Access Compliance Report

Public Rights-of-Way

(Curb Ramps)

Intersection ID: 13908	Main Street: BAY_ST	Cross Street: ST_JULIEN_ST	Location:	N
ADA ID: 87073E6D2C4A	Ramp Type: Perp	Initial Pass/Fail: Fail	Overall Compliance: No	Severity Score: 8.75
Codes/Mitigation Info/Possible Solution		Field Measurements/Component Compliance

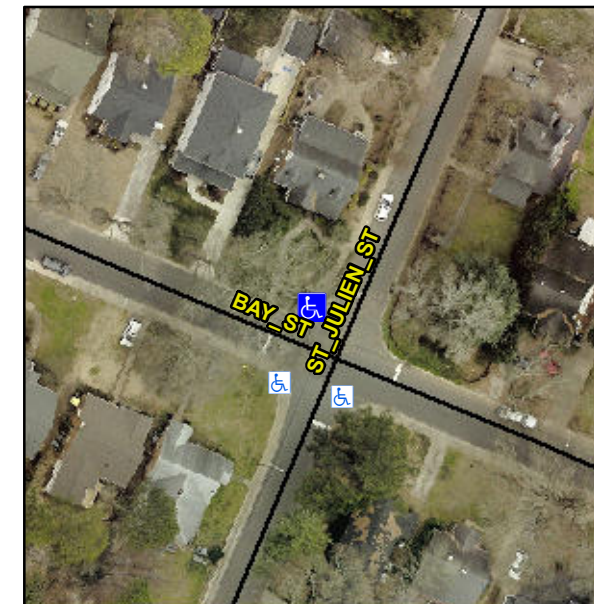
Not Found, R304.5.1

Compliance	Description	Data	Compliance	Description	Data
N/A	Ramp Length (in)	59.0	Yes	Ramp Slope (%)	5.4
No	Ramp Width (in)	44.5	Yes	Ramp XSlope (%)	2.0
N/A	Flare Type LT	N/A	N/A	Flare Type RT	N/A
N/A	Flare Slope LT (%)	N/A	N/A	Flare Slope RT (%)	N/A
N/A	Flare Traversable LT?	N/A	N/A	Flare Traversable RT?	N/A
N/A	Landing Length (in)	N/A	N/A	DWS Provided?	N/A
N/A	Landing Width (in)	N/A	N/A	DWS Contrast?	N/A
N/A	Landing Slope (%)	N/A	N/A	DWS Length (in)	N/A
N/A	Landing X Slope (%)	N/A	N/A	DWS Full Width?	N/A
N/A	Landing Curb? (Y/N)	N/A	N/A	DWS Offset (in)	N/A
N/A	Shared Landing?	N/A			
N/A	Gutter Ponding?	N/A	N/A	Gutter Slope (%)	N/A
N/A	Gutter Lip Ht (in)	N/A	N/A	Gutter X Slope (%)	N/A
N/A	Painted X Walk1?	No	N/A	Painted X Walk2?	N/A
	X Walk 1 Direction	To SW		X Walk 2 Direction	N/A
N/A	X Walk 1 Width (in)	N/A	N/A	X Walk 2 Width (in)	N/A
	X Walk 1 Slope (%)	0.2		X Walk 2 Slope (%)	N/A
	X Walk 1 X Slope (%)	0.4		X Walk 2 X Slope (%)	N/A

Remove & Replace Entire Ramp.
